Department of Energy

Ms. Margo T. Oge, Director
Office of Radiation Programs (ANR-458)
U. S. Environmental Protection Agency
401 M Street, SW
Washington, DC 20460

**TECHNICAL ASSISTANCE TO THE
U.S. ENVIRONMENTAL PROTECTION AGENCY
ON 40 CFR PART 191**

May 11, 1992

Figure 4-1. Containment Requirements in the Three-Bucket Approach

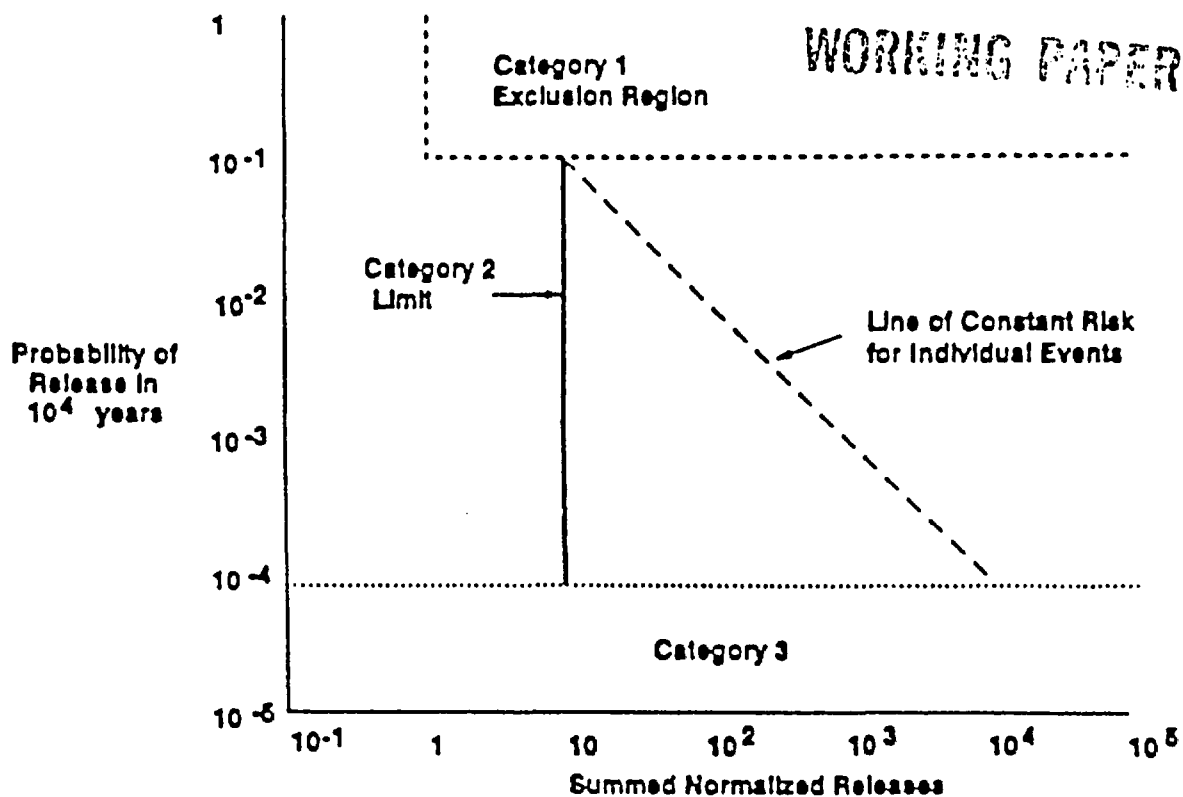
This approach has some problems that must be resolved before it could replace the present containment requirements. The system CCDF in category 1 would be incomplete, and the upper level of probability would always be less than 1. Moreover, the upper level of this incomplete system CCDF also would be different for each repository, making the requirement inconsistent. One partial solution would be to normalize the incomplete system CCDF so that it would be complete for anticipated events. The requirement would still be inconsistent and it would not be traceable to the fundamental standard that applies to the entire disposal system, not just to some events. If, to overcome this difficulty, all events were included in the category 1 CCDF to make it complete, the need for precise probability estimates would be the same as the present approach.

Another problem is the nonuniformity of category 2. As can be seen in Figure 4-1, the proposed requirement is 1,000 times as restrictive for events with probabilities of 0.0001 as for events with probabilities of 0.1. This nonuniformity could be eliminated by using the line of constant risk in Figure 4-1 as the category 2 limit. The accuracy requirements for probability estimates would then be uniform for the entire category.

The NRC staff has claimed that the "three-bucket approach" may simplify licensing or permitting of repositories, but the concept and some definitions need clarification, and some modifications are needed to reduce inconsistencies and nonuniformities. It is not clear that categories 1 and 2 can be shown to fulfill the total-system risk requirements of the fundamental criterion.
